Facilities & Operations Committee Meeting September 2026

RE: North Penn High School BP-2
Change Order Request #23 ASI 01 – Additional Shaft wall

PROJECT: *(name and address)* North Penn High School Renovations Bid Package 2	**CONTRACT INFORMATION:** Contract For: Mechanical Construction Date: 08-14-2026	**ASI INFORMATION:** ASI Number: 01 Date: 01-20-2026
OWNER: *(name and address)* North Penn School District 401 E. Hancock Street Landsdale, PA 19446	**ARCHITECT:** *(name and address)* Hord Coplan Macht, Inc. d/b/a SCHRADERGROUP Studio 555 E. North Lane, Suite 5100 Conshohocken , PA 19428	**CONTRACTOR:** *(name and address)* JBM Mechanical, Inc 3273 Gun Club Road Nazareth, PA 18064

Drawing Number:
BP2- C008

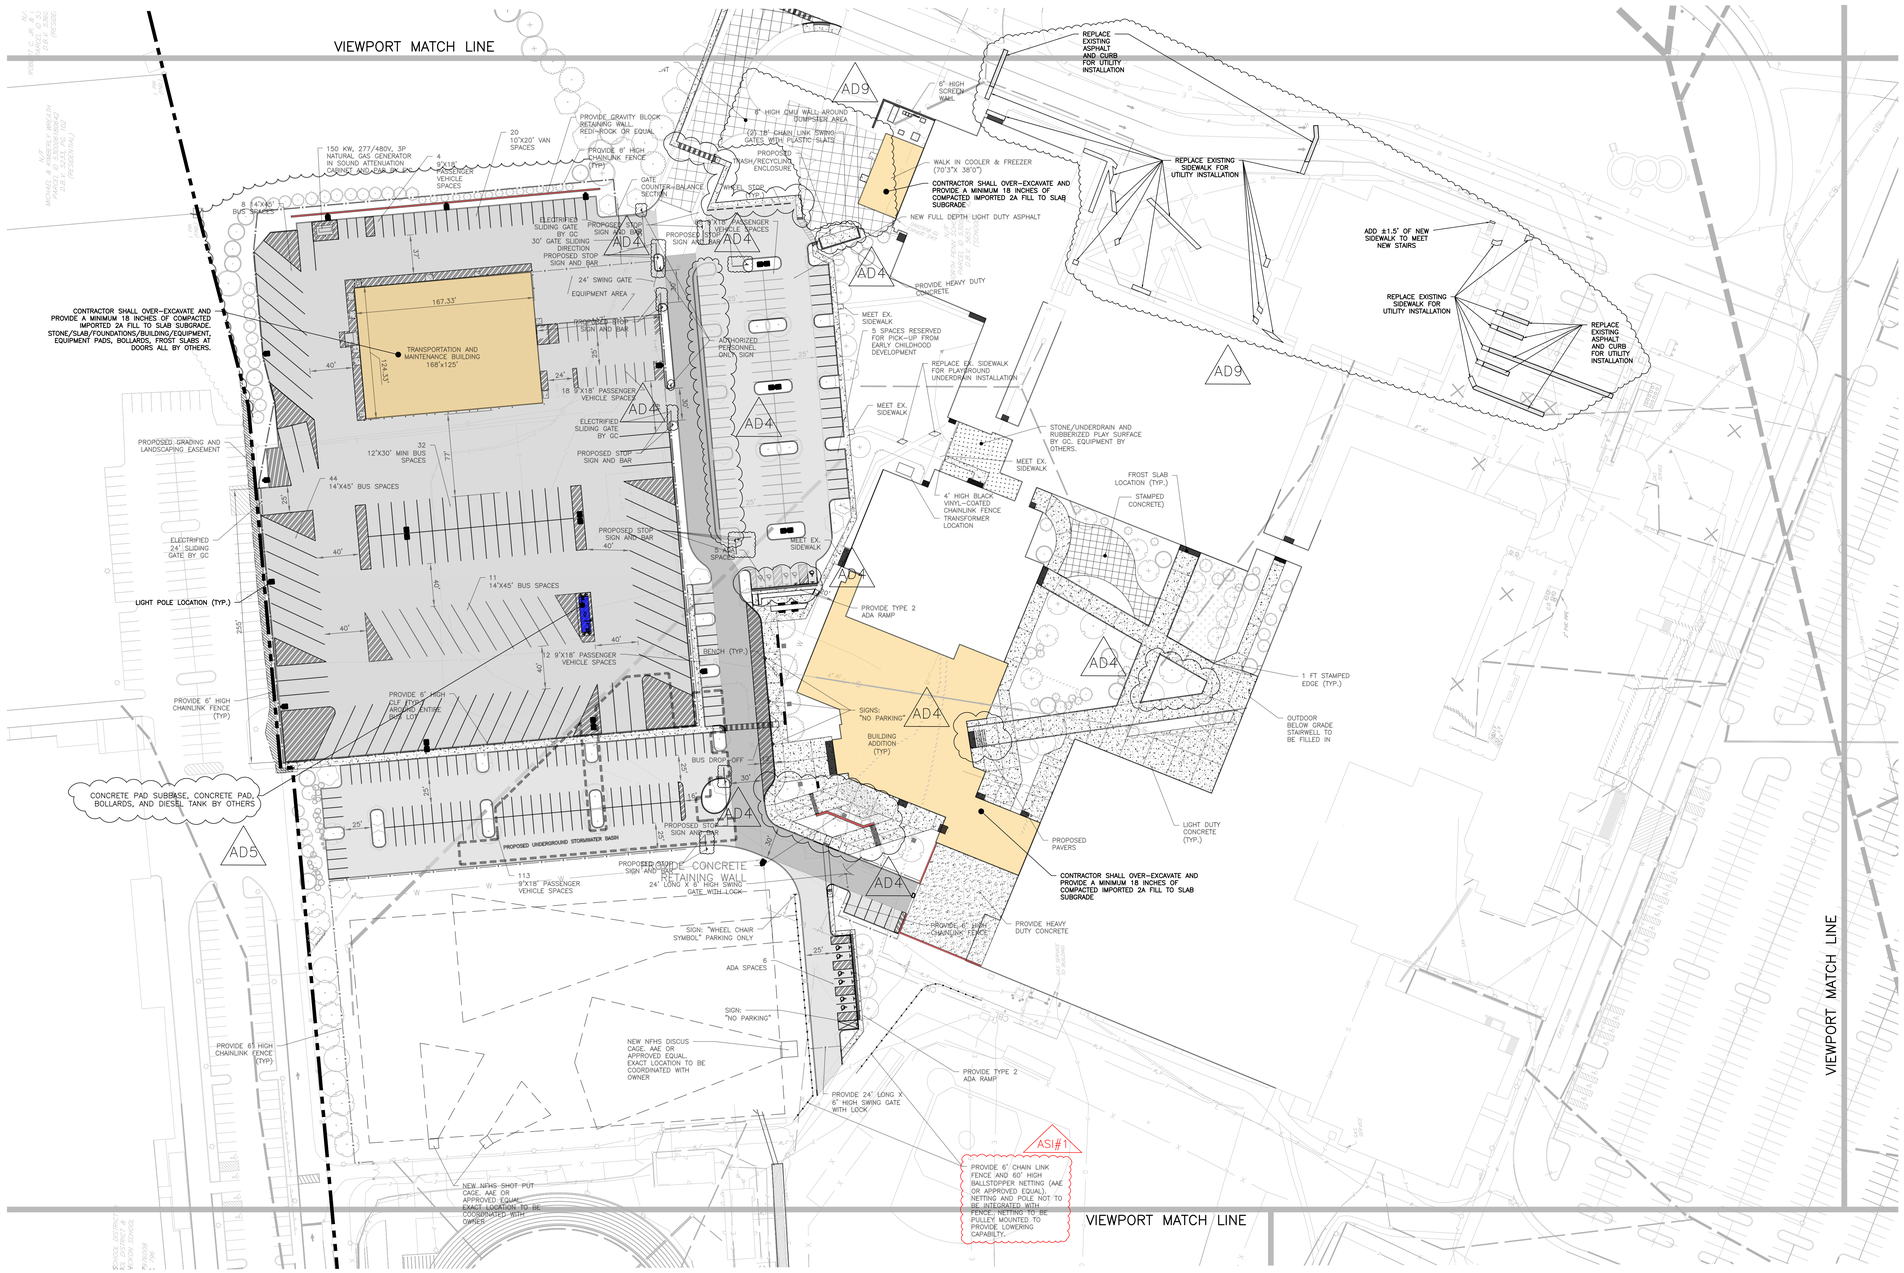
Revisions to Civil Set:
- Drawing BP2-C008; REPLACE sheet in its entirety (attached). Revise the ball stopper netting height and associated fencing connection.

Drawing Number:
BP2-A122.A1

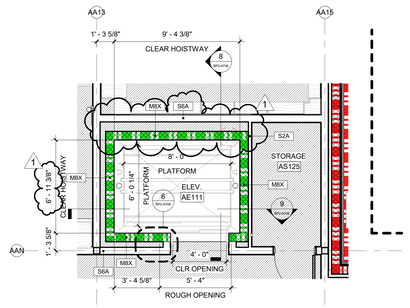
Revisions to Architectural Set:
- Drawing BP2-A122.A1; REPLACE sheet in its entirety (attached). Height of pendant lighting from Second Floor elevation to bottom of fixture provided.
- Drawing BP2-A121.E; CLARIFICATION that 6A WOOD CELING SYSTEM direction in LIBRARY E155 to run short distance to align with lighting.
- Drawing BP2-A708; REPLACE sheet in its entirety (attached). Revise ELEV1 hoistway plan dimensions, layout, and associated head and jamb details.

Drawing Number:
BP2-A708

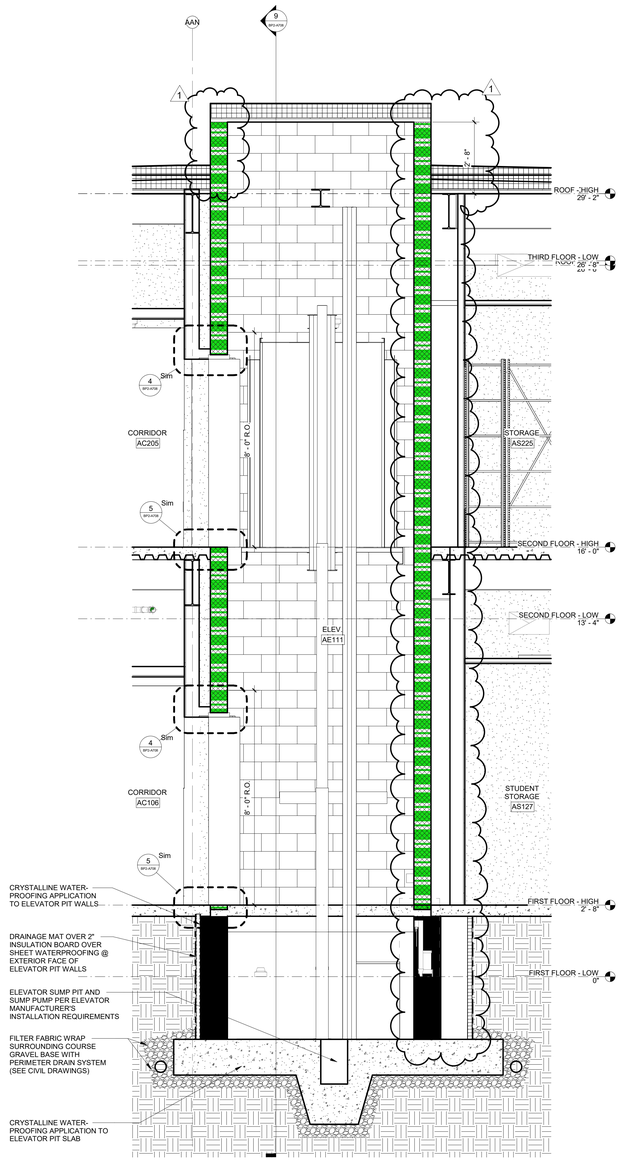
Please see below the costs associated with the changes listed in ASI 01, issued 01-26-2026. This proposal includes providing and installing an added Layer of 1" Shaft Liner to Elevator Doors per Details 4 and 6/BP2-A708.

- **Added Layer of 1" Shaft Liner to Elevator Doors per Details 4 and 6/BP2-A708 of ASI-001.**

Revisions to Structrual Set:
- Modifications to structural steel framing adjacent to elevator shaft shall be made per revised sheet BP2-A708 and reflected on Revise & Resubmit For Record submittals.

Drawing Title:
DRAINAGE PLAN - A

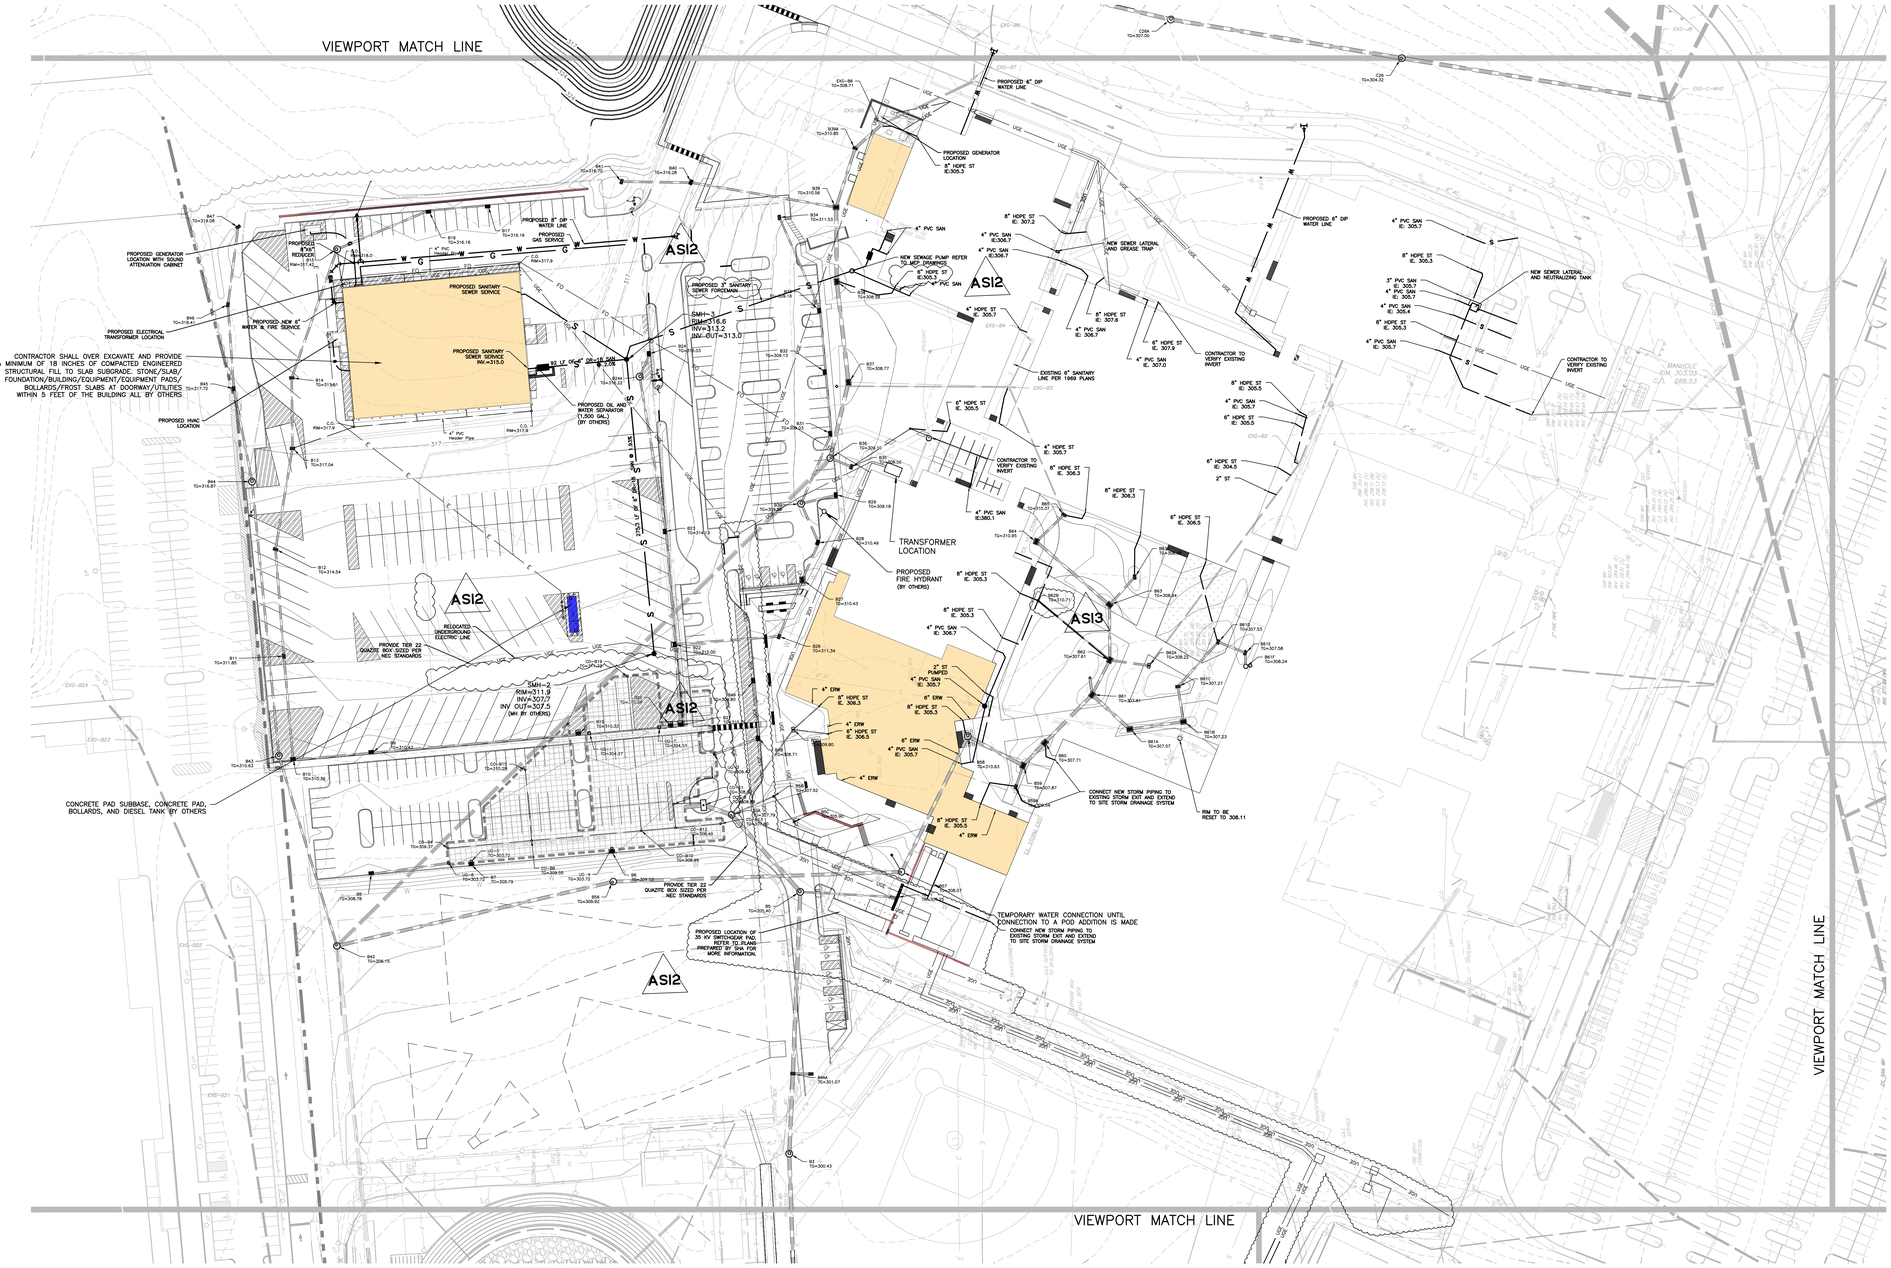
3. Drainage Plan A (BP2-C017) has been modified to make plan revisions including but not limited to:
    - **To add 2'x2' structure B62B to the courtyard storm network to connect roof drains to structure B62.**
    - **To raise B59A by 1' to work with revised courtyard grading. This will not affect the structure's shop drawing.**

- **To raise the existing inlet in Area B Equipment Yard to allow proper drainage**

Drawing Title:
EXTERIOR STAIR DEMOLITION

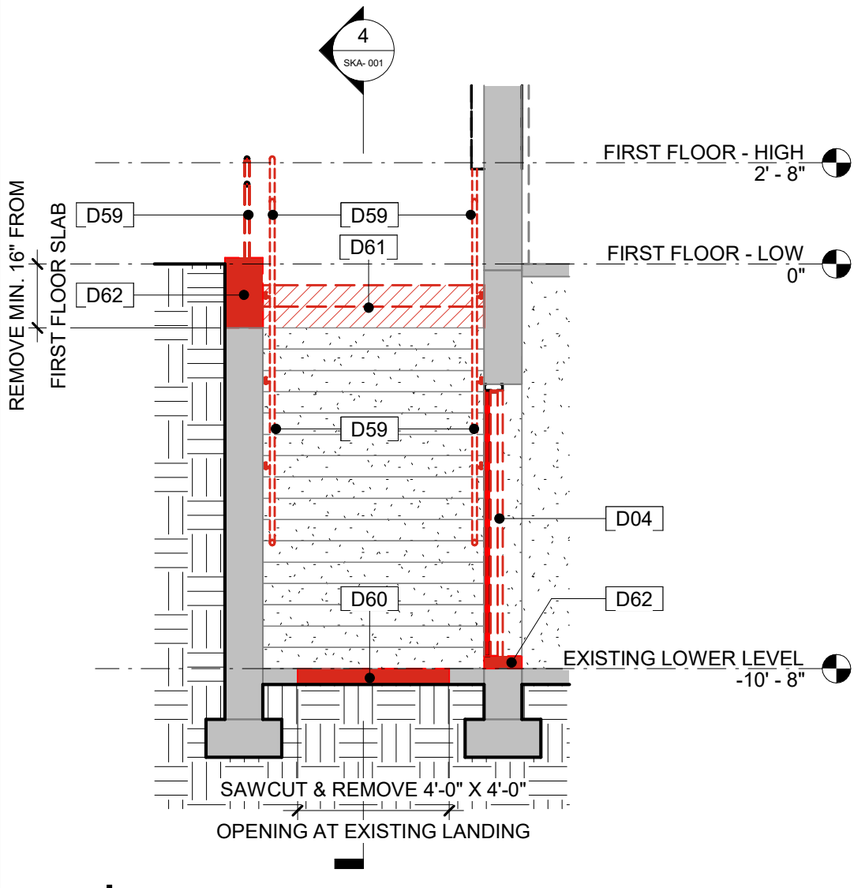
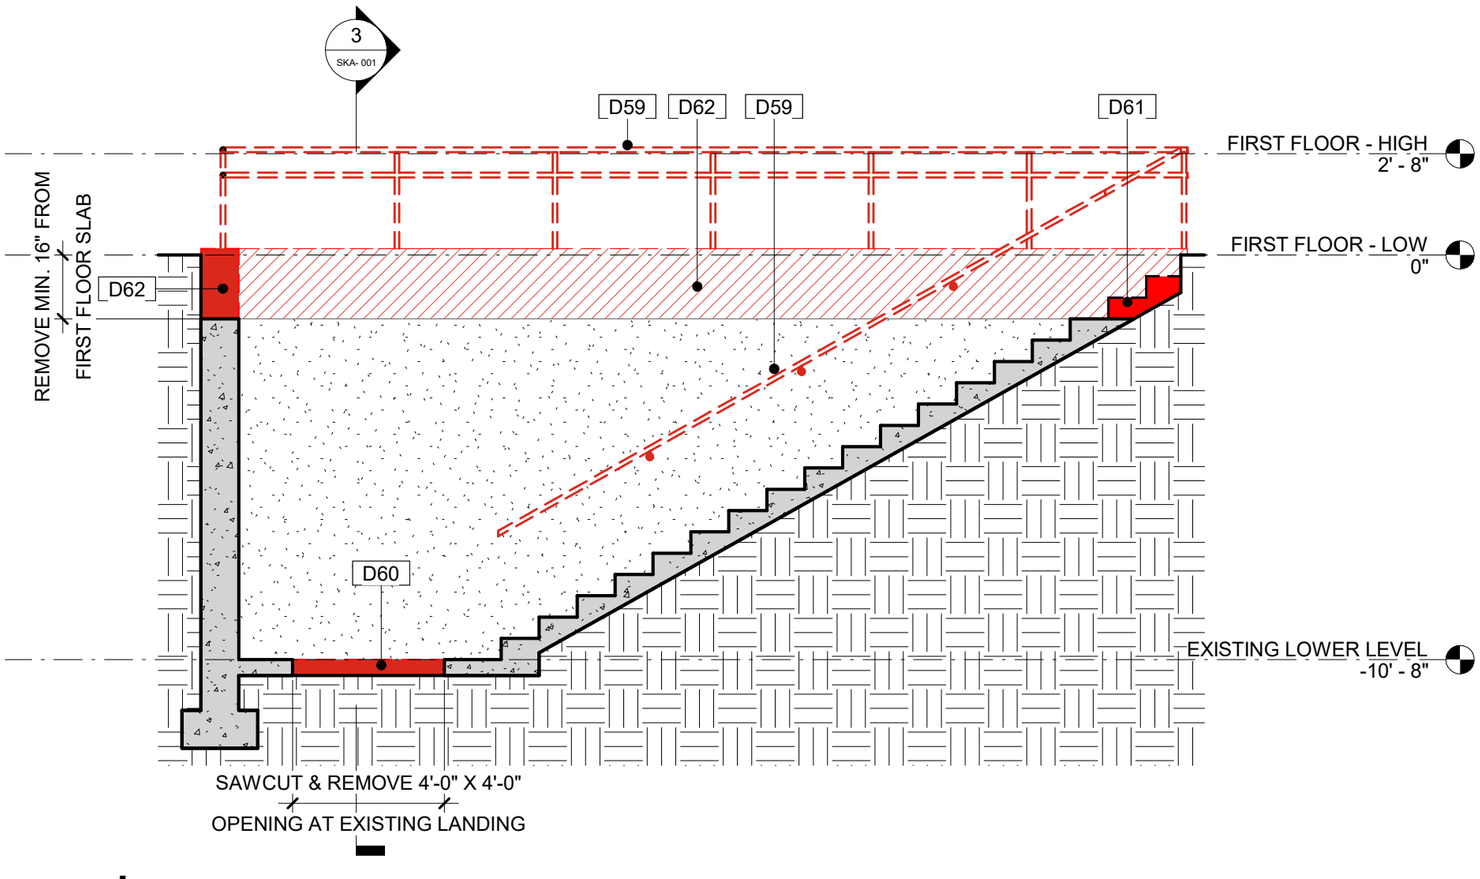
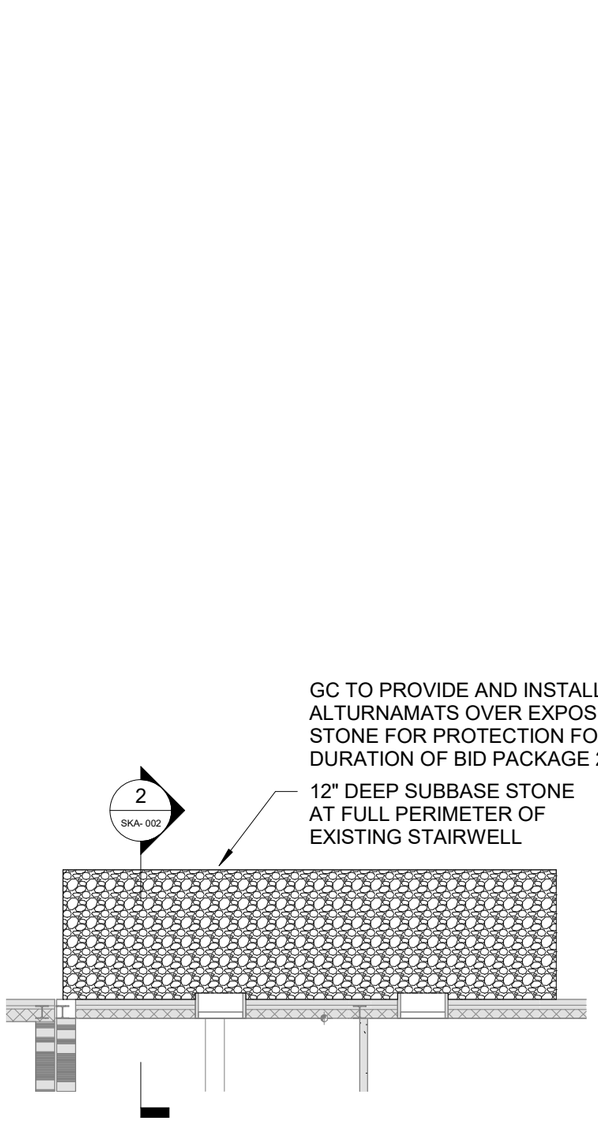
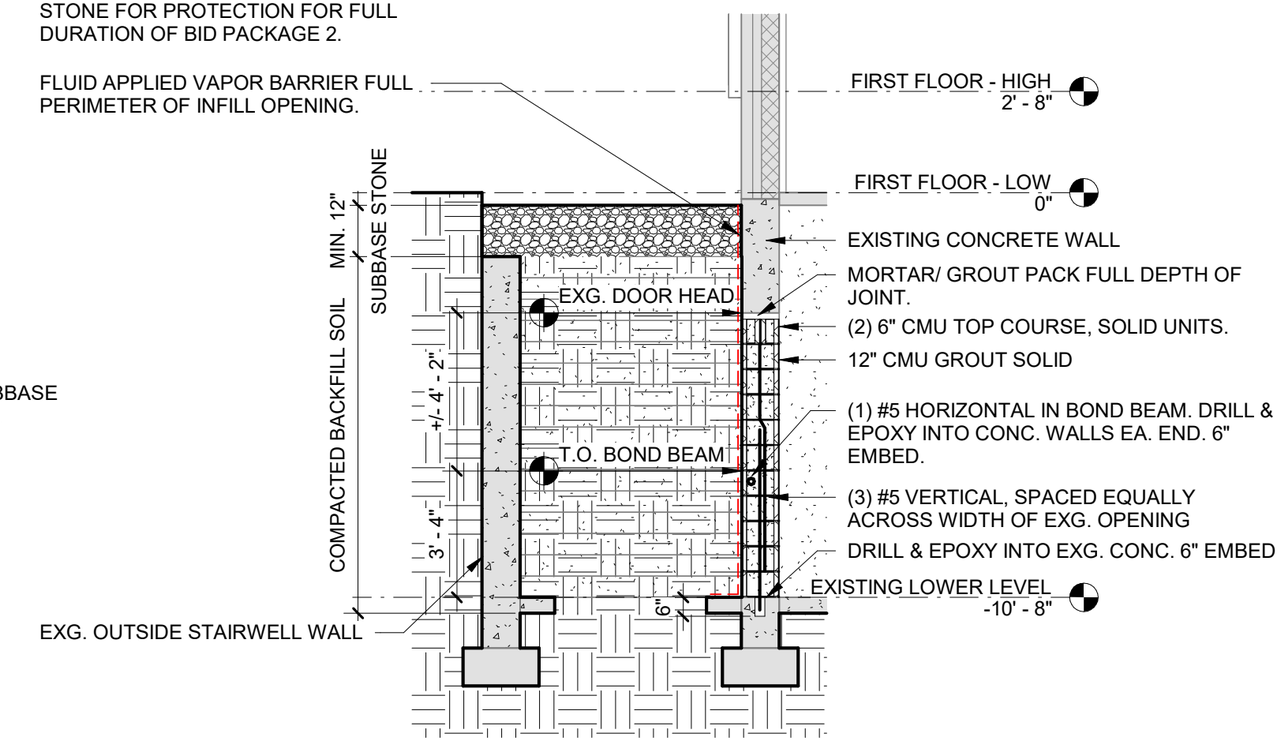
EXTRA WORK/CHANGE DESCRIPTION:
Hammer Steps and Wall below grade, leave in place to be buried. Hammer bottom of stairs to allow drainage.
NO MATERIAL WILL BE REMOVED FROM SITE. BACKFILLING OF STAIRS IS NOT INCLUDED IN THIS PRICE
NO SAW CUTTING IS INCLUDED. Surface will be rough as they will be broken off and not neatly removed.

ASI 03.1GC: Courtyard Grading Revisions (Per RFI GC-008 Courtyard Grading)
ASI 03.2GC: H-Pod Stairwell Demolition & Infill
ASI 03.3GC: Area B Equipment Yard Storm Inlet & Concrete Paving

BP2-CSKE-10 SCALE: 1/8" = 1'-0"

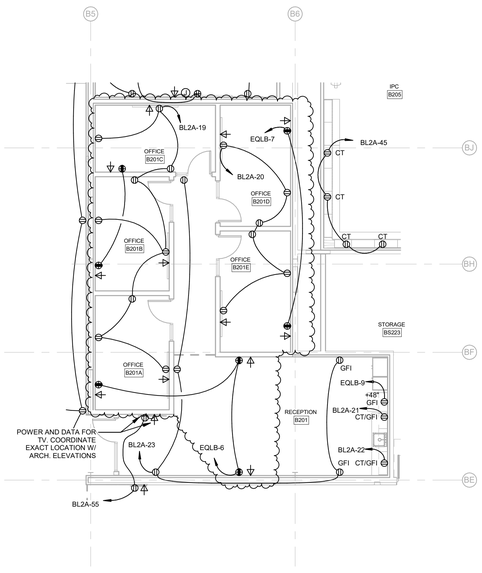
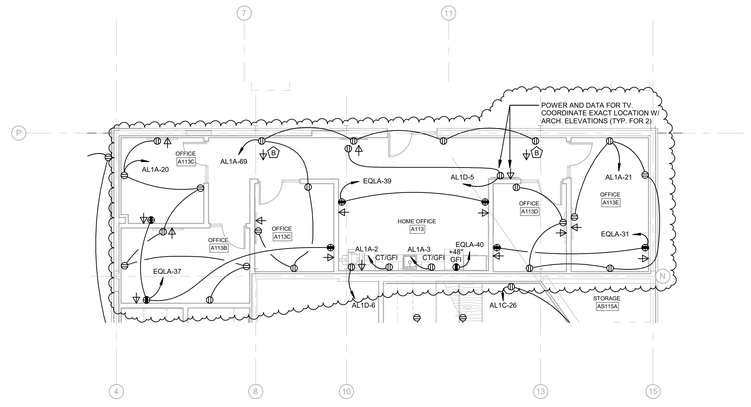
14.03 Sketch BP2-CSKE-10; **ADD** sketch BP2-CSKE-10 dated 06/18/2026.
